CITY OF ALBUQUERQUE

Sites: La Cuentista III Rosa Parks/Kimmick – D10E002D

Re: Drainage Ordinance (14-5-2-11) Violations for Erosion and Sediment Control

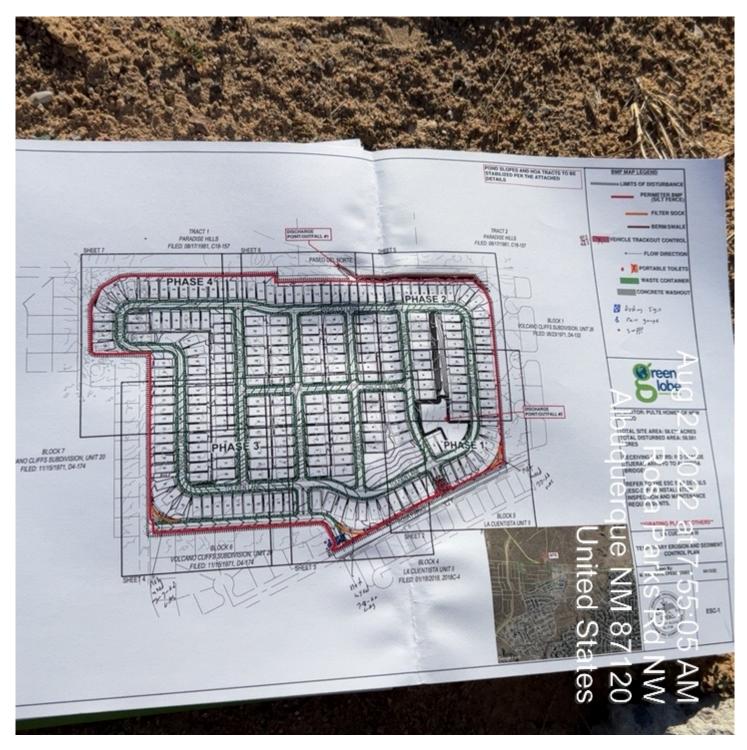
1. The property owner's NOIs were missing for the stockpile/staging area, so they don't have NPDES Permit coverage. NPDES Permit coverage is required for all disturbed areas. Tracts 1-5 Block 6 are entirely covered by recent land disturbing activities. There is also a large area of land disturbance on the portion of Tract 1 Blk 2 Volcano Cliffs Subdivision Unit 26 that is due east of Tract 5 and where a water tank, porta potty, and other haul roads are located. An additional haul road is located on Tract 8 Blk 1

2. A SWPPP wasn't available onsite for the area of Construction Support Activities. Pulte's SWPPP didn't include the required information on the staging area (NOIs & SWPPP Map of BMPs) either.

3. BMPs were missing at the staging/stockpile area

- 1. Each property owner's NOI(s) must be submitted and approved by the City, then added to the SWPPP. Alternatively Guzman or Pulte may provide coverage under their own NOI if they have either a lease or an easement on the lot.

- 2. An updated SWPPP Map of the staging/stockpile area with appropriate BMPs and stabilization must be submitted and approved by the City and then added to either Pulte's SWPPP or a new SWPPP for the stockpile area.

- 3. Compliance with CGP 2.1.4 is required. Ensure that all stormwater controls (BMPs) are maintained and remain in effective operating condition during permit coverage per CGP 2.1.4. If at any time you find that a stormwater control needs routine maintenance, CGP 5 requires you to immediately initiate the needed maintenance work and complete such work by the close of the next business day. When the problem requires a new or replacement control or significant repair, install the new or modified control and make it operational, or complete the repair, by no later than seven (7) calendar days from the time of discovery.
